**Parking Assessment**  
**Site Redevelopment – Proposed Housing**  
**553-559 Islington Street**  
**Portsmouth, NH**

**RE: Request for Site Plan Approval at 553 – 559 Islington Street, Tax Map 157 / Lot 3**

On behalf of 553 – 559 Islington Street, LLC we hereby submit the attached and enclosed Site Plans for TAC Approval for Proposed Redevelopment at 553 – 559 Islington Street. The project proposes the construction of a small building addition with the associated and required site improvements. The site is currently, and is proposed to remain, a six unit building.

# PROPOSED REDEVELOPMENT 553-559 ISLINGTON STREET PORTSMOUTH, NEW HAMPSHIRE PERMIT PLANS

**SITE LAYOUT PLAN**  
**C3**

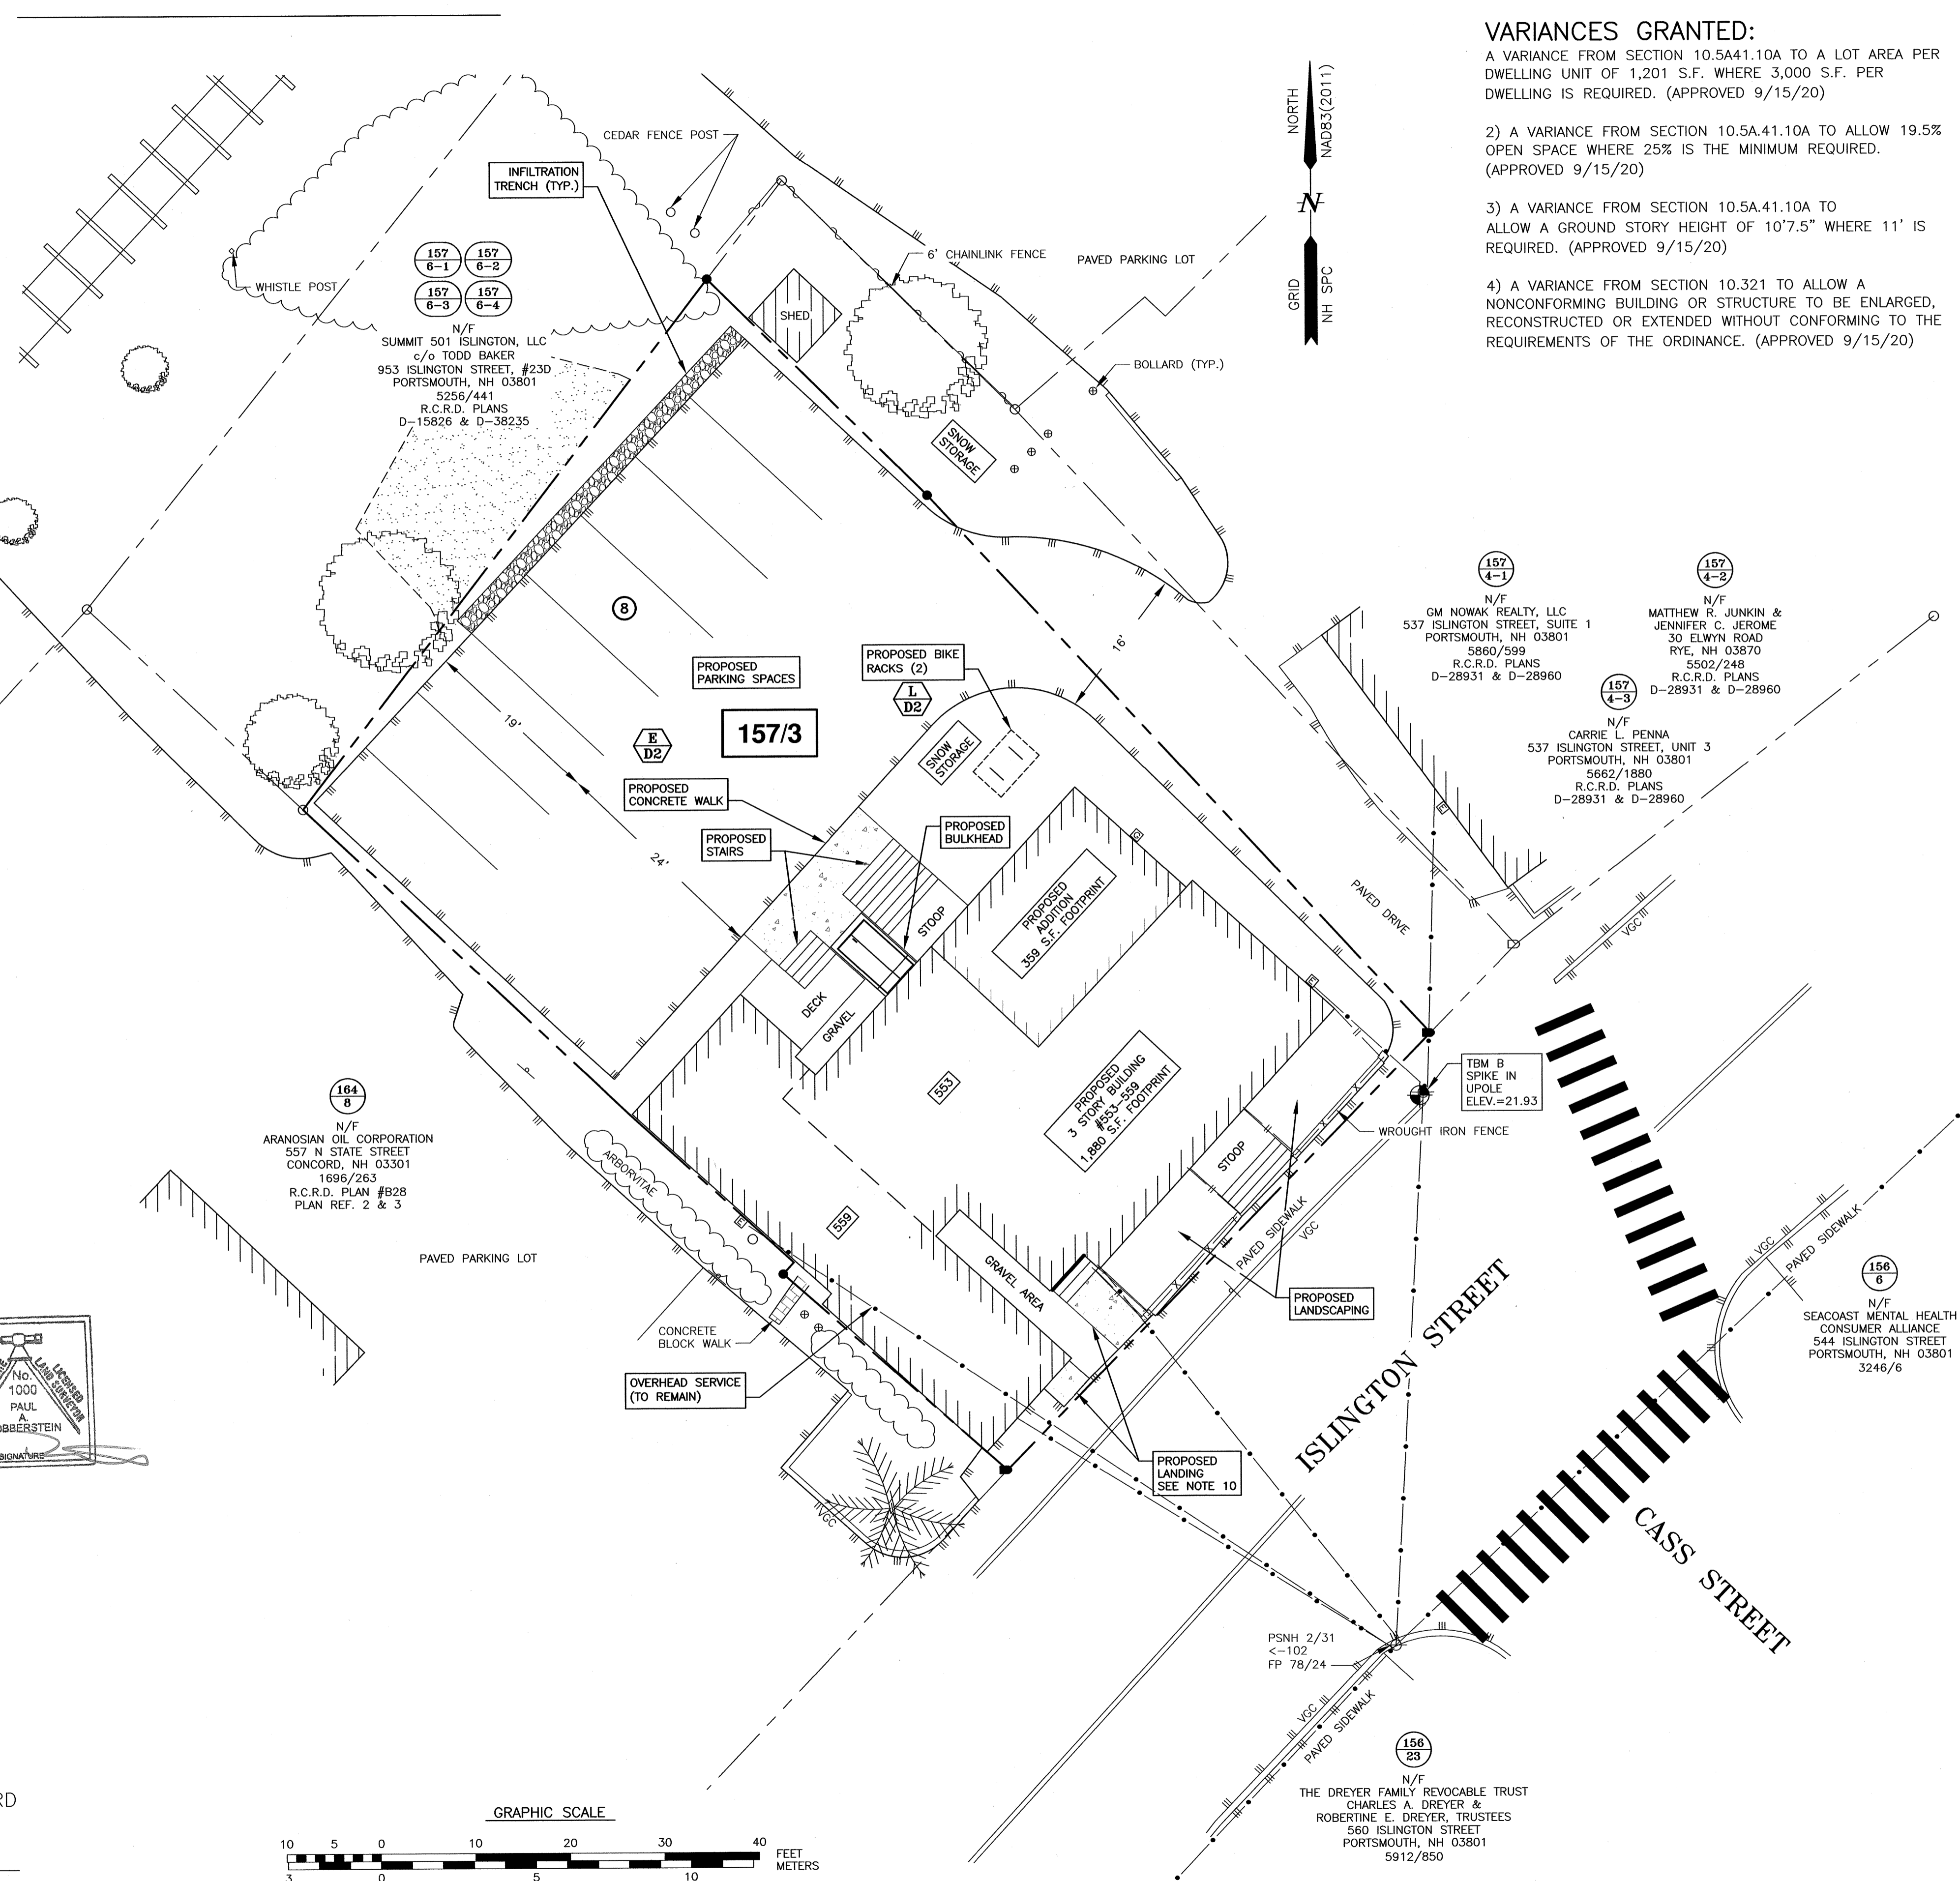
1. The sewer shown on this plan ‘by the City’ will not happen prior to this project. Do not flow fill the existing sewer. It is ok to show a future sewer line and ‘coordinate with the City’ in the future. Right of access for the future installation of this line by the City should be acquired during this process. If needed, sewer should be replaced out to the edge of parking from the building now before new stairs are constructed. New sewer lateral will connect at that spot in the future. **Notes to clarify this are on Sheet C4 as Note 8. The plan notes the right of access shall be granted to the city, also see Note 13 on Sheet C3. The plan notes construction of the lateral for the future connection.**

2. A temporary construction easement shall be provided to the City for future installation of sewer line and the plan shall be updated to note the required easement. **The plan notes the right of access shall be granted to the city, also see Note 13 on Sheet C3.**

UTILITY PLAN **C4**

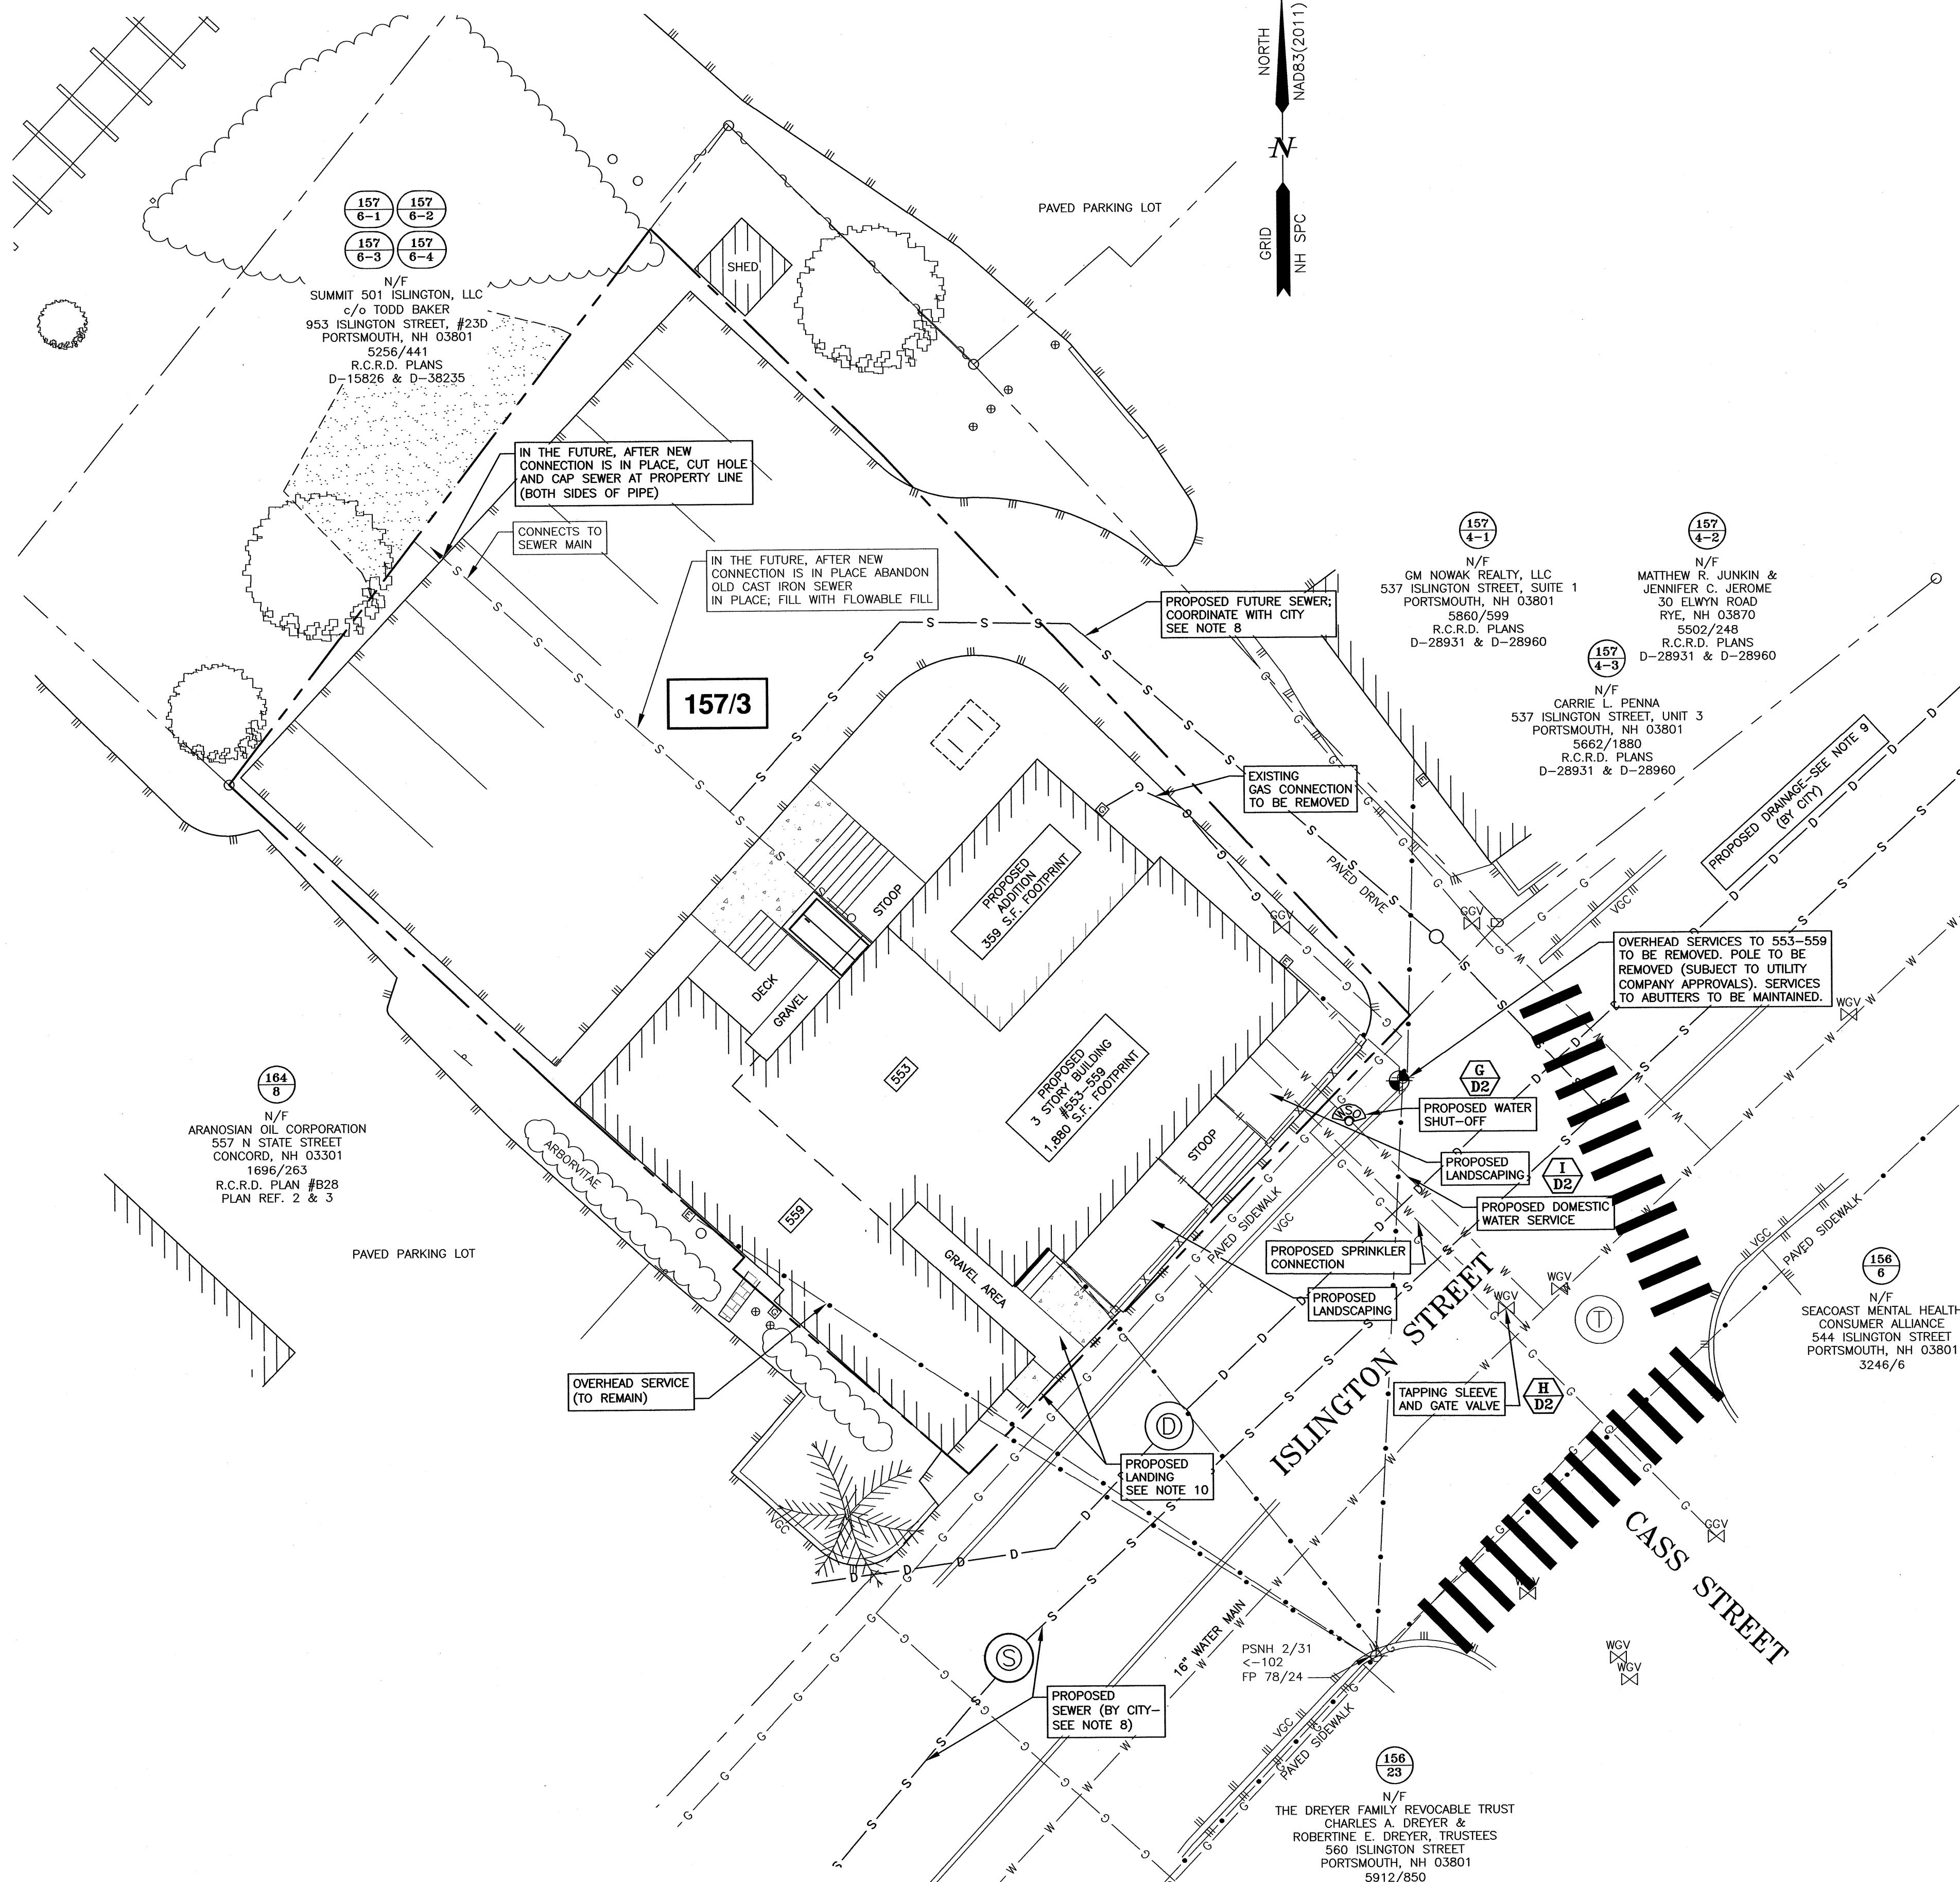
3. Shut off for the domestic water tap shall be in the sidewalk, not in the curb line as shown. **The location has been revised as requested – see Sheet C4.**

4. Applicant to coordinate with Eversource on possible removal of pole in front of the building. The pole in front of the building is there only because of the attachment point of the overhead service. Relocating the service attachment should be investigated, so that the pole can be removed permanently. **The plan shows the elimination of the pole as requested; however this is subject to confirmation from Eversource as well as the other providers on the pole. See Sheet C4.**
